## APPENDIX D1

### REQUEST FOR INFORMATION (RFI)

# Request For Information

Project No: 6515 Contract No: C-007 RFI No: 6515-C-230-007\_004 Rev: 0  
 Meliadine Project  
 Site RFI Initiator: Matt Gallant Date: 2016-10-11

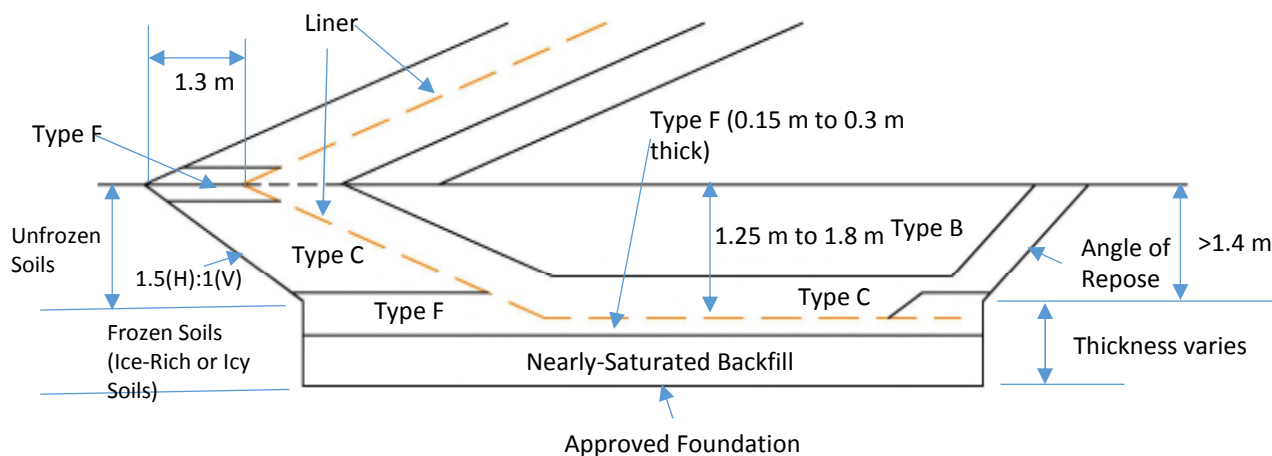
MTKSL is requesting further clarification on Scenario 3B & 3C: Key Trench Excavation (2.8m, Ice Rich Soil)

In areas where excavation depth greater than 1.8 m is required, MTKSL is proposing to sub-excavate to the required depth with vertical walls from the design 1.8m trench toes (see attached sketch).

Please confirm that this approach for sub-excavation is acceptable.

We do NOT agree with the upstream side slope of 2.5(H):1(V) for the key trench that was proposed by the Contractor. This slope is too flat and is not consistent with the design intent.

The designed key trench side slopes (both upstream and downstream) were "angle of repose". In the construction drawings, the key trench side slopes with "angle of repose" were assumed to be 1.5(H):1(V). Based on the current field conditions, the actual "angle of repose" is steeper than 1.5(H):1(V). To reduce overall key trench excavation and backfill, we propose the following:

- 1) 1.5(H):1(V) for upstream key trench side slope, which is the same as shown in the construction drawings; it is also acceptable if the upstream key trench side slope is slightly steeper than 1.5(H):1(V).
- 2) The actual "angle of repose" for the downstream key trench side slope, which is steeper than 1.5(H):1(V), as proposed by the Contractor.
- 3) Nearly vertical wall excavation below the toes of the upstream and downstream key trench slopes within the unfrozen active layer zone (1.4 to 1.8 m). This is generally consistent with the plan proposed by the Contractor.

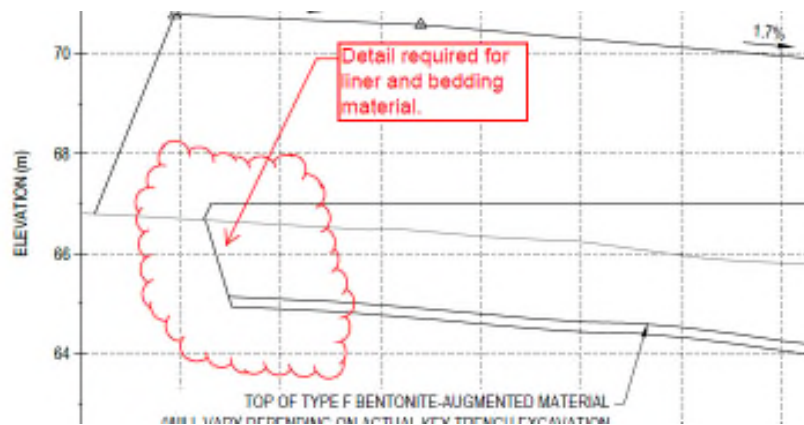
MTKSL is requesting tie in details for the termination points at either end of the key trench for DCP 1 and 5, more specifically related to requirements for the liner and bedding material in the area.

For either end of the key trench for D-CP1 and D-CP5, the following construction details should be followed:

- 1) Place a liner bedding layer of Type F (mixture of Type C and bentonite) over the entire excavated slope at the end of the key trench and compact the Type F layer to form a smooth surface for liner installation over the end slope. The minimum thickness of the compacted Type F over the key trench end slope would be 0.2 m;

- 2) Place and compact extra Type F over the key trench (upstream side) end corner to form a rounded corner for liner installation;
- 3) Extend the typical liner in the key trench towards the key trench (upstream side) end corner, curve (wrap) over the key trench (upstream side) end corner, and then further extend a minimum of 3 m downstream over the compacted Type F layer on the end slope of the key trench. The liner over the key trench end slope should be welded together with the liner at the key trench bottom;

- 4) Place a layer of Type C as an upper bedding over the completed liner area at the end of the key trench. The thickness (perpendicular to the slope) of Type C should be about 0.5 m. No mechanical compaction is required for the Type C layer immediately over the liner; and

- 5) Backfill the remaining key trench end area with Type B, similar to the typical section.

A hand sketch is attached for information.

2) Design changes for the option with lower Liner bottom elevation and no Type K material

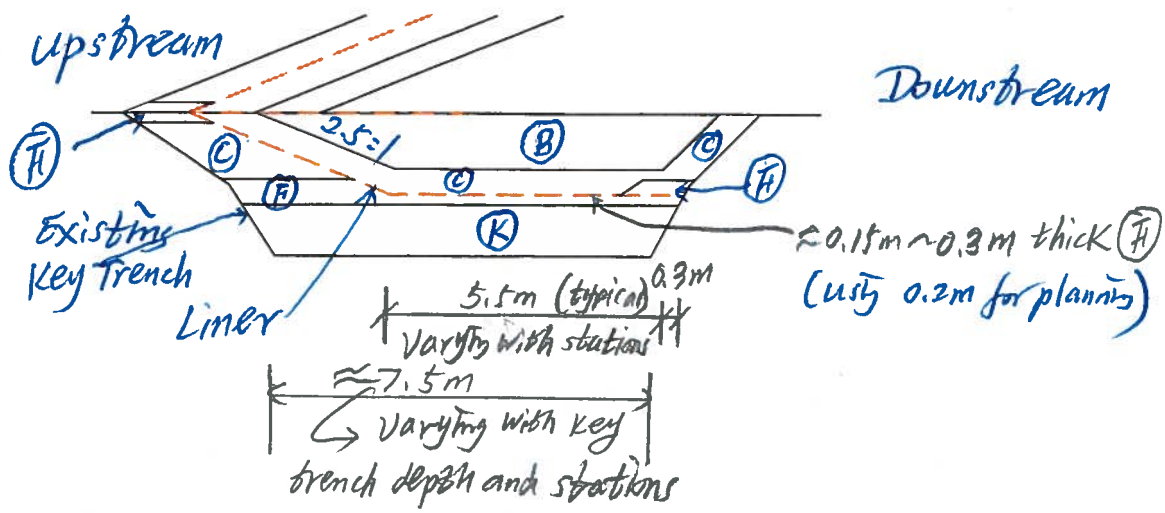
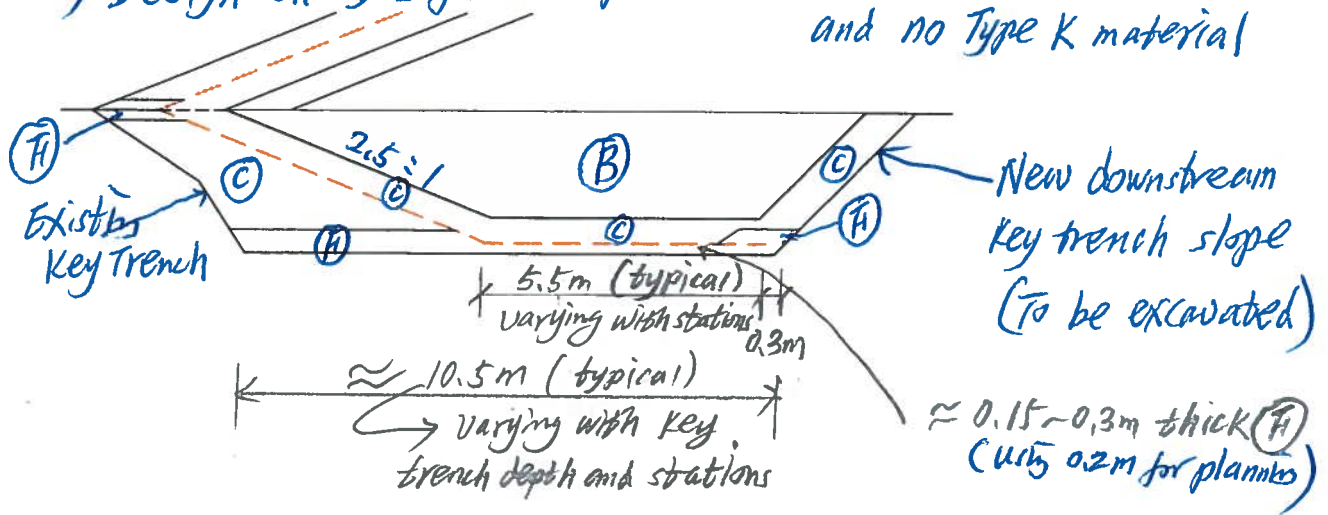
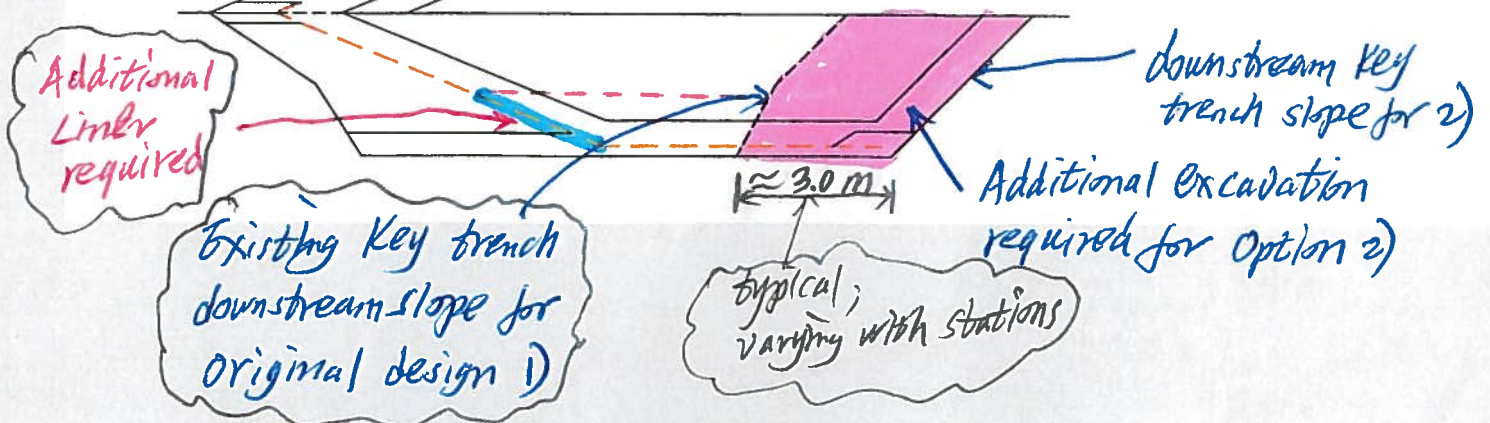
- Heating aggregate will not be possible until mid-February at the earliest using the on-site batch plant facilities.
  - Recommend placing 0.15 to 0.30 m thick Type F directly on base of key trench at the approved depths (approximately 2.8 m) and lowering the liner for remainder of D-CP1 from Stations 0+310 to 0+580 – all other overliner design elements will remain.

Based on the sketches (typical sections with 2.8 m key trench depth), the material quantity changes are roughly estimated for planning, assuming the changes for the option will be applied to Stations 0+310 to 0+580 (about 270 m):

Type B: 2,940 m<sup>3</sup> (increase);  
 Type C: 1,690 m<sup>3</sup> (increase);  
 Type F: 210 m<sup>3</sup> (increase); therefore, bentonite increase: approximately 42 tonnes  
 Type K: -2,170 m<sup>3</sup> (decrease); therefore, the total Type C will slightly decrease (1690+210-2170 = -270 m<sup>3</sup>);  
 Liner (ES3): 909 m<sup>2</sup> (increase), including overlapping; and  
 Key trench excavation: 2,670 m<sup>3</sup> (increase).

The estimated quantity changes are provided for AEM's planning and decision making. The actual quantities will depend on the actual construction details and could be different.

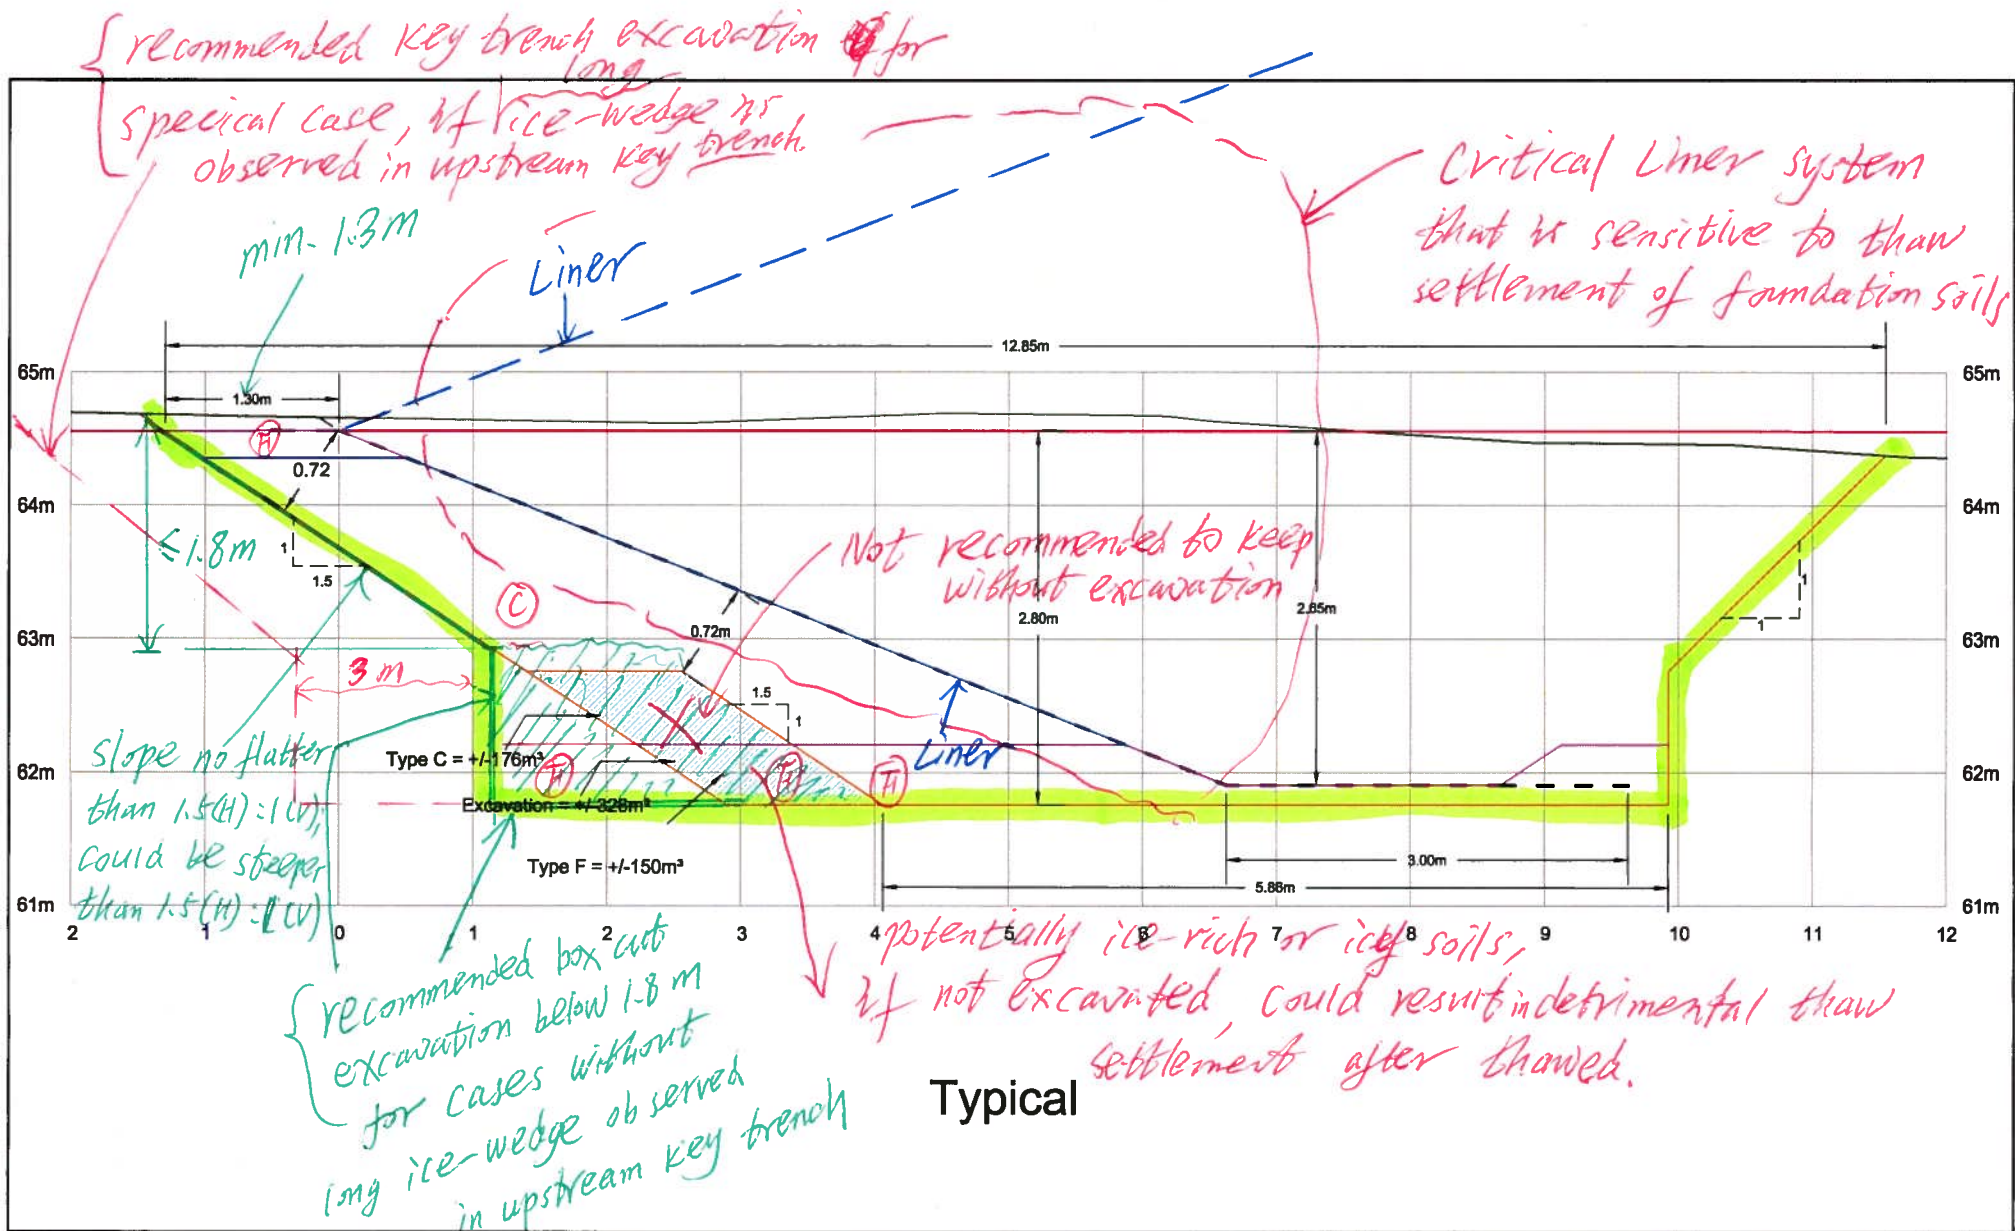
As an alternate option to reduce the excavation and Type F quantity MTKSL is proposing to use the existing minimum cover and slope parameters from the IFC design to create a step in the slope at the 1.8m elevation where the design key trench floor was planned to be encountered. (per attached detail) potential saving = 1.1m<sup>3</sup>/Ln.m of excavation and 0.5 m<sup>3</sup>/Ln.m Type F.

Please confirm approved up stream slope detail for D-CP05.

Technically, we do not recommend the key trench excavation option that was proposed by MTKSL in this RFI for the following reasons:

- 1) If the key trench needs to be excavated below 1.8 m to up to 2.8 m, that means the foundation soils below the 1.8 m depth must be either ice-rich or icy soils. If these soils are thawed, potential thaw induced settlements would be relatively great.
- 2) To reduce the potential risk of detrimental thaw settlement below the critical portion of the line, the ice-rich or icy soils below the critical portion of the liner system should be removed and replaced with thaw-stable backfill.

Based on MTKSL's original sketch, notes are made in the attached sketch to show the recommended excavation plan for the case with a required key trench depth of up to 2.8 m.

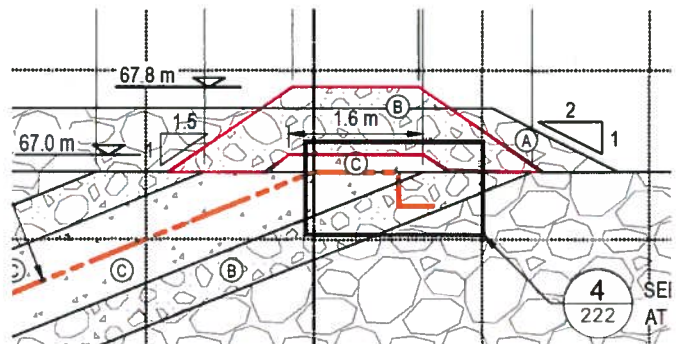
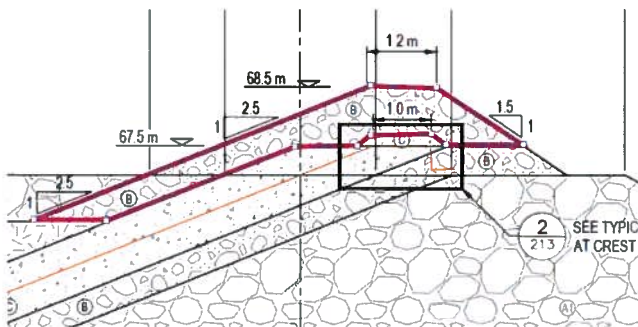
Based on survey data and approved design changes MTKSL has calculated the neat line volume of Type B to be 16,191 m<sup>3</sup>. This volume considers D-CP1 to be constructed with no substitutions where Type B is required (including the additional excavation) and D-CP5 to maintain Type B as per design above OG and a minimum thickness of 300mm from OG down within the Key Trench. The remainder of D-CP5 Key Trench Type B will be substituted with Type H.

1. Replace the Type B material within the very top cover portion of the Dikes with Type B material produced from UG ROM as this location is already adjacent to Type A material. ( see below)
2. Replace the Type B material within the very top cover portion of the Dikes with the 0-125mm Type H ( see below)
3. Produce an additional quantity of clean Type B from the A1 supply which is not ideal as the quantities are already tight for this material.

Option 2 to replace Type B with Type H (esker sand and gravel) has two issues. The esker sand and gravel (Type H) is susceptible to surface erosion and therefore, is not a suitable material to be placed over the dike crest. Secondly, the majority of Type H required for construction of D-CP1 has not been produced at this stage. The availability of additional, qualified Type H is uncertain.

TYPICAL LINER KEY-IN AT CREST - REVISED DESIGN

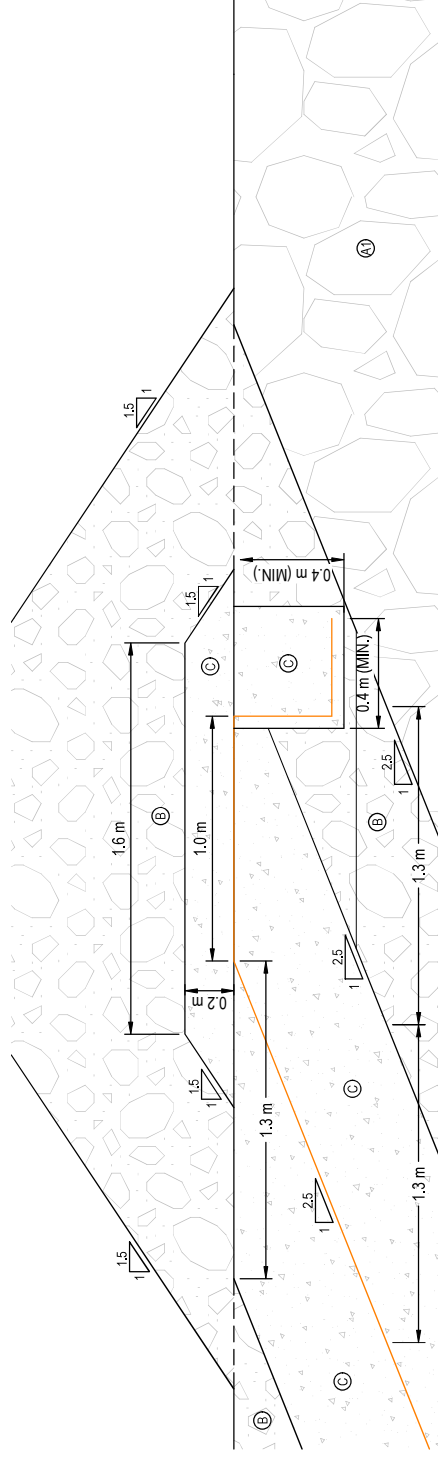
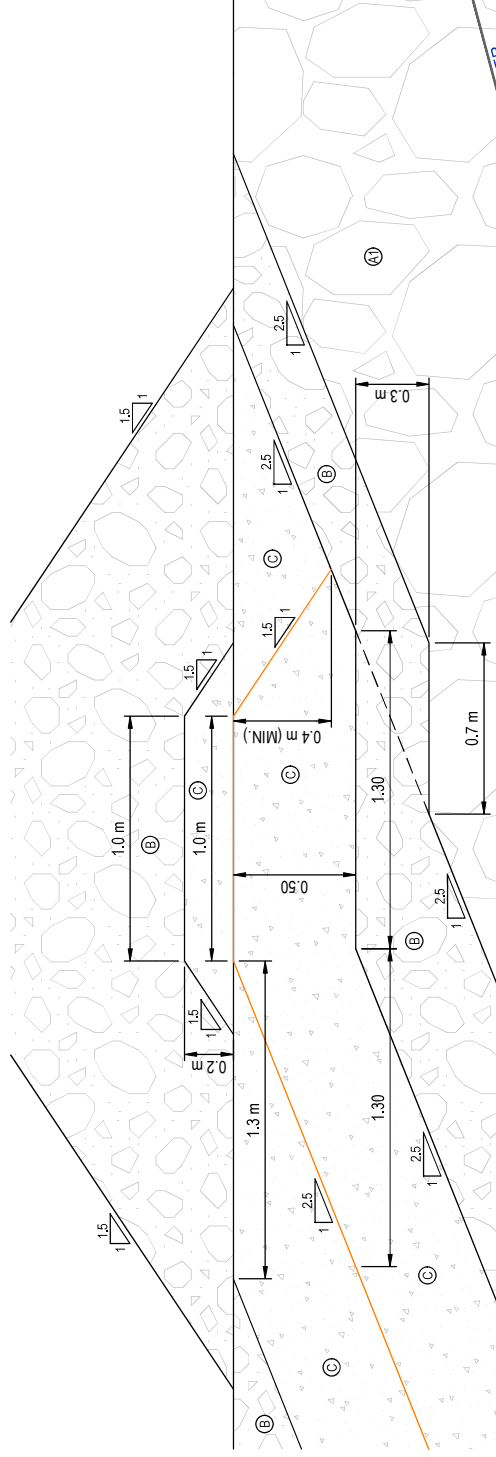
In the meeting with Luciano and Duy on October 28, 2016, Luciano suggested some changes to avoid sharp corners of the liner in anchoring the liner over the dike crest. As directed, we have prepared two drawings (see attached) to show the proposed design changes for your review:

- 1) Proposed dike crest design change No.1 for D-CP1.
- 2) Proposed dike crest design change No.1 For D-CP5.
